UNITED STATES
NUCLEAR REGULATORY COMMISSION
WASHINGTON, D. C. 20555

SUBJECT: WAIVER OF CRGR REVIEW OF TOPICAL REPORTS WCAP-10271
SUPPLEMENT 2 AND WCAP-10271 SUPPLEMENT 2, REVISION 1
"EVALUATION OF SURVEILLANCE FREQUENCIES AND OUT OF
SERVICE TIMES FOR THE ENGINEERED SAFETY FEATURES
ACTUATION SYSTEM"

SUBJECT: WESTINGHOUSE TOPICAL REPORTS WCAP-10271 SUPPLEMENT 2 AND
WCAP-10271 SUPPLEMENT 2, REVISION 1, "EVALUATION OF
SURVEILLANCE FREQUENCIES AND OUT OF SERVICE TIMES FOR THE
ENGINEERED SAFETY FEATURES ACTUATION SYSTEM"

Figure 3.1. Distribution of 48 safety feature actuation signal unavailabilities for solid state and relay systems. (Only signals with identical logic and permissives are considered.)

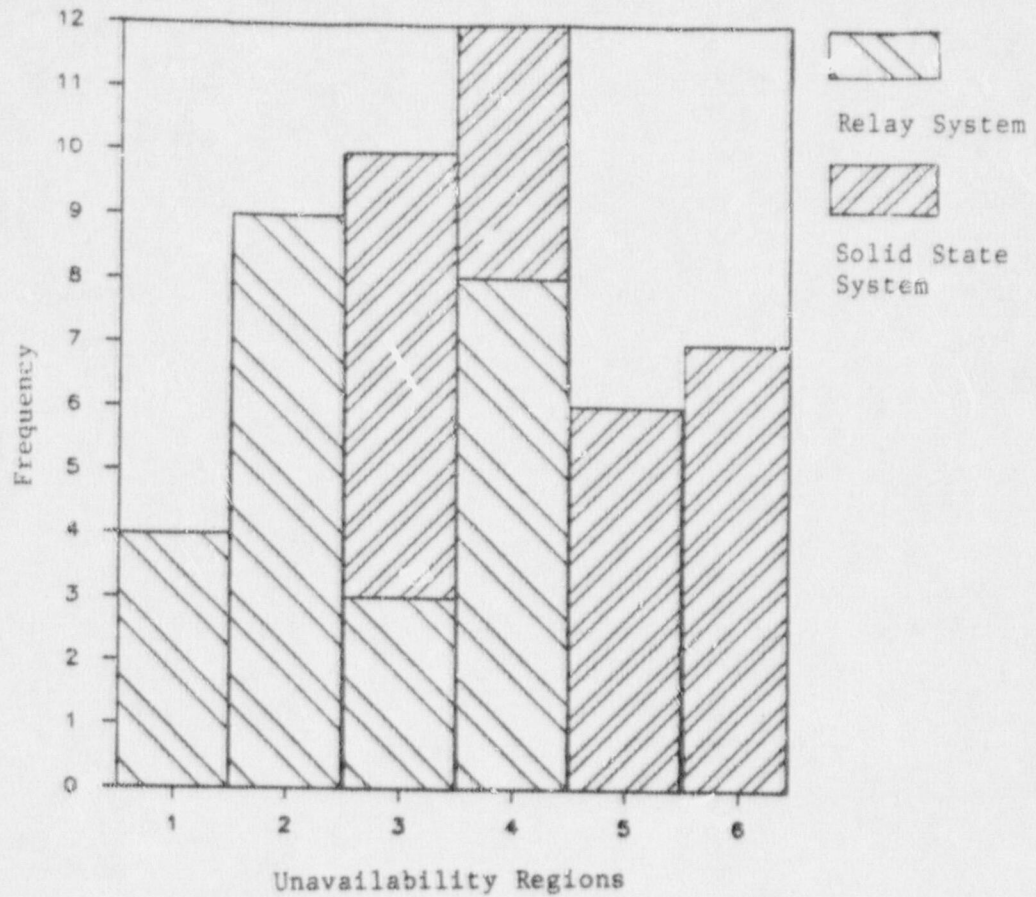
(Figure 3.1 shows the frequency distributions of 24 solid state and 24 relay signal unavailabilities selected in both cases with identical logic requirements and permissives. The distributions were compiled by BNL from WOG data to see the concentrations and spreads of these unavailabilities. The figure shows that the signal unavailabilities of the solid state system are consistently higher than those of the relay system. The distributions relate to the current set of surveillance parameters. Unavailability data given in the submittals shows that other sets of STI and AOT values provide similar distributions, i.e., signal unavailability data for the solid state systems envelope those obtained for the relay systems.)

Figure 5.1. Millstone Unit 3
Support State Model

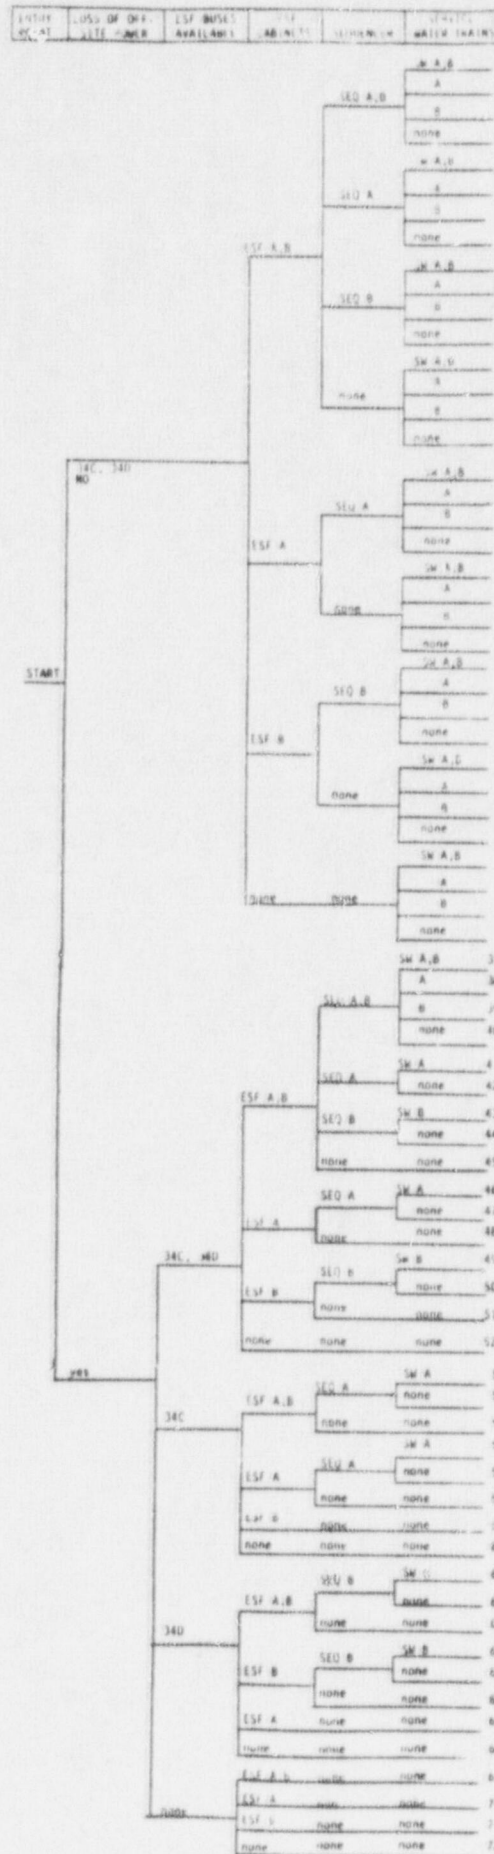
The support system model is analyzed conditional on the initiating event and the partial or total unavailability of the above support systems. Figure 5.1 shows the support state model of the Millstone 3 PSS for initiators where the ESFAS is important. The model results in 72 states, which by their impact on the frontline systems, can be reduced to 8 unique support states. The definition of these support states is given in Table 5.3.

It is clear from the model shown in Figure 5.1 that the probability of being in any particular support state will depend on the unavailabilities of the individual ESFAS trains and the whole ESFAS. Any changes in these unavailabilities will impact the state probabilities.
